Access Compliance Report

Public Rights-of-Way

(Curb Ramps)

Intersection ID: 43689	Main Street: PORTSTEWART_LN	Cross Street: RISELEY_LN	Location: S
ADA ID: 752ECFBA04D9	Ramp Type: PerpDiag	Initial Pass/Fail: Fail	Overall Compliance: No
Codes/Mitigation Info/Possible Solution		Field Measurements/Component Compliance	
Severity Score: 8.75

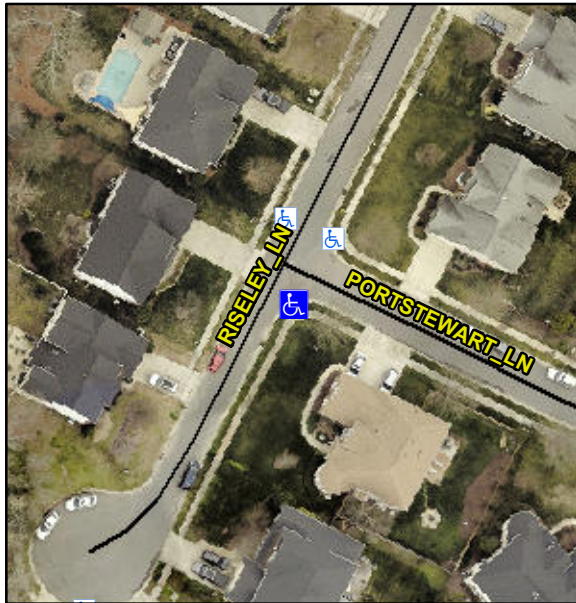
Not Found, R304.5.1

Compliance	Description	Data	Compliance	Description	Data
N/A	Ramp Length (in)	50.5	Yes	Ramp Slope (%)	5.6
No	Ramp Width (in)	43.0	Yes	Ramp XSlope (%)	1.6
N/A	Flare Type LT	N/A	N/A	Flare Type RT	N/A
N/A	Flare Slope LT (%)	N/A	N/A	Flare Slope RT (%)	N/A
N/A	Flare Traversable LT?	N/A	N/A	Flare Traversable RT?	N/A
N/A	Landing Length (in)	N/A	N/A	DWS Provided?	N/A
N/A	Landing Width (in)	N/A	N/A	DWS Contrast?	N/A
N/A	Landing Slope (%)	N/A	N/A	DWS Length (in)	N/A
N/A	Landing X Slope (%)	N/A	N/A	DWS Full Width?	N/A
N/A	Landing Curb? (Y/N)	N/A	N/A	DWS Offset (in)	N/A
N/A	Shared Landing?	N/A			
N/A	Gutter Ponding?	N/A	N/A	Gutter Slope (%)	N/A
N/A	Gutter Lip Ht (in)	N/A	N/A	Gutter X Slope (%)	N/A
N/A	Painted X Walk1?	No	N/A	Painted X Walk2?	No
	X Walk 1 Direction	To NE		X Walk 2 Direction	To NW
N/A	X Walk 1 Width (in)	N/A	N/A	X Walk 2 Width (in)	N/A
	X Walk 1 Slope (%)	3.3		X Walk 2 Slope (%)	2.1
	X Walk 1 X Slope (%)	1.2		X Walk 2 X Slope (%)	3.7

Remove & Replace Curb Ramp With Two New Directional Ramps or Equivalent.
